WATER
RESOURCES
DEPARTMENT

The Water Resource Department has received your request for special standards on the Pat Manning well located in Township 7S, Range 2W, Section 15 of Marion County.

STATE OF OREGON
WATER RESOURCES DEPARTMENTREQUEST FOR VARIANCE OR EXCEPTION TO THE RULES AND REGULATIONS
FOR CONSTRUCTION OF A WATER WELL*.

- 1) A diagram showing the pertinent features of the proposed well design and construction (attach additional sheet if necessary):

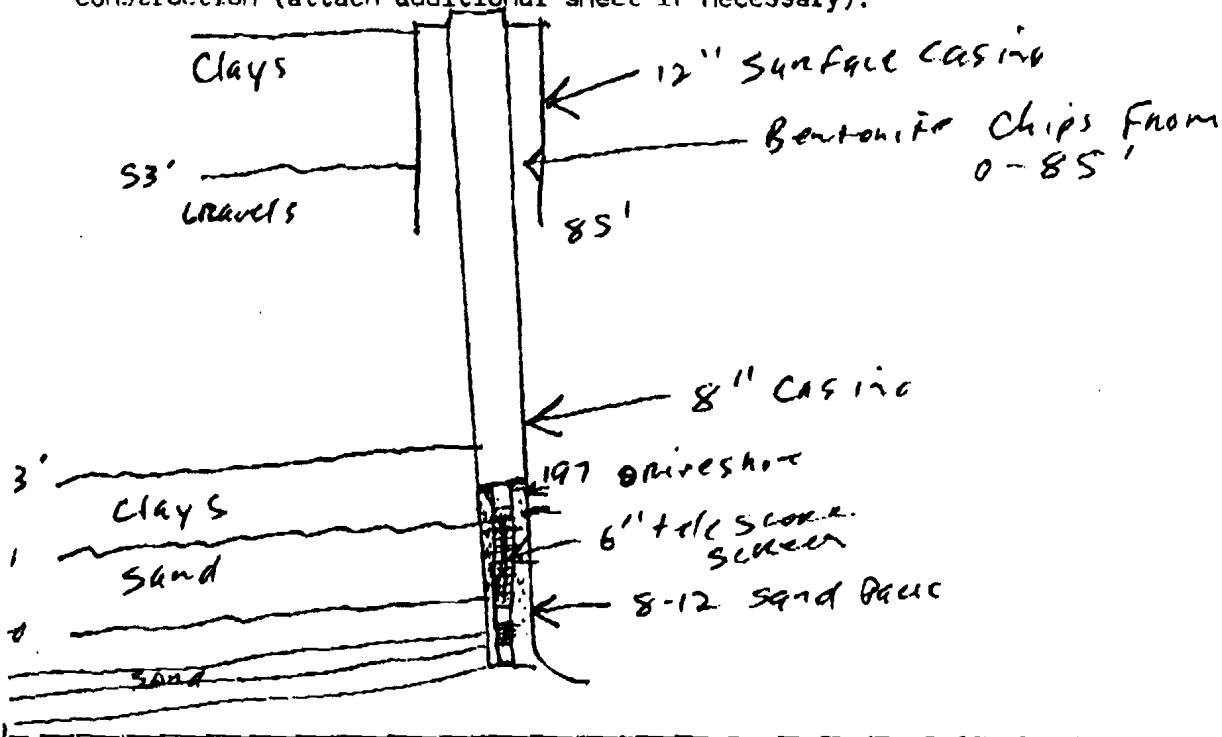
(6) The reasons that compliance to the rules and regulations for minimum standards will not result in a satisfactory well: WOULD LIKE
PERMISSION TO USE ^{BENTONITE} CHIPS FROM 85' TO
GROUND SURFACE, INSTEAD OF CEMENT FOR
IF CASING MIGHT BE ADVANCED TO BASALT IN
THE FUTURE

Bentonite Chip Seal From 0-85' instead of
the Normal 20' Seal to assure surface
water does not commingle with lower waters

Your request is approved with the following conditions:

1. Only bentonite chips shall be used in the sealing interval
2. A weighted line or tamping bar shall be placed in the annular space to inhibit bentonite bridging.
3. The bentonite shall be poured at a rate not to exceed 3 minutes per 50 pound sack.
4. Care will be taken not to allow dust from the bentonite to enter the annular space.
